SERVICE CAMPAIGN BULLETIN

CAMPAIGN REF: 02J
TITLE : Air Line Fastener Torque Check
DOCUMENT # : 11 F 017
AFFECTED VEHICLES : 12C Coupe and Spider

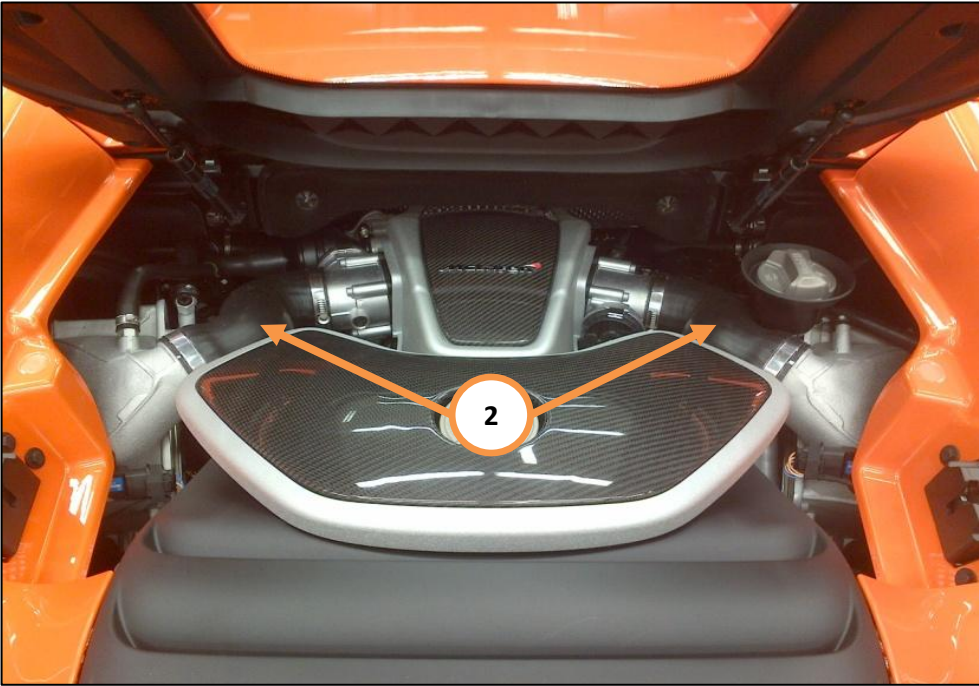
1. Please refer to AA-RM-02A03-04-005 – Remove/install engine compartment side cover to remove the side covers (1).

2. Remove both water charge air cooler to throttle body hoses (2).

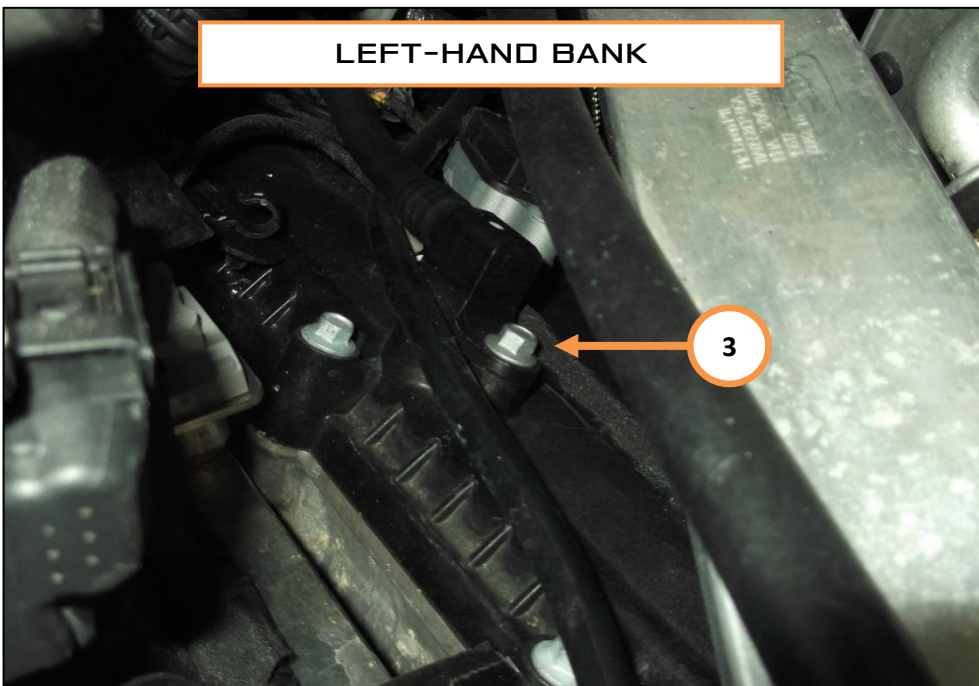
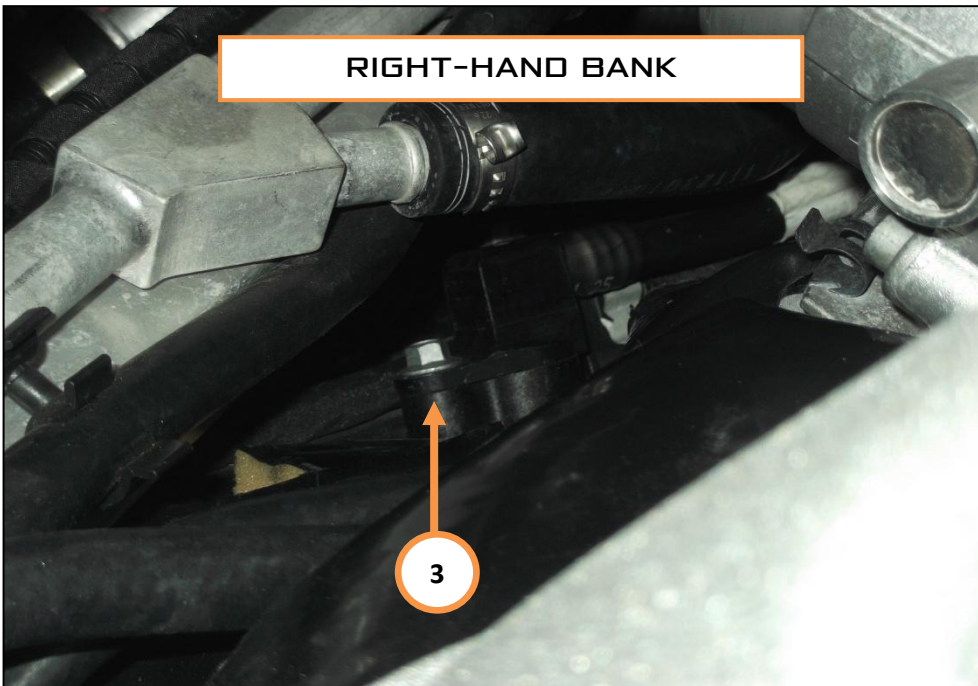
3. Locate the air line fastener (3) which is positioned at the top of the camshaft cover.

4. Set the torque wrench to 10 Nm and check that the fastener is tightened to the correct torque (10 Nm) (3).

If the torque is incorrect continue to torque up to 10 Nm.
If the torque is correct no further action is required.
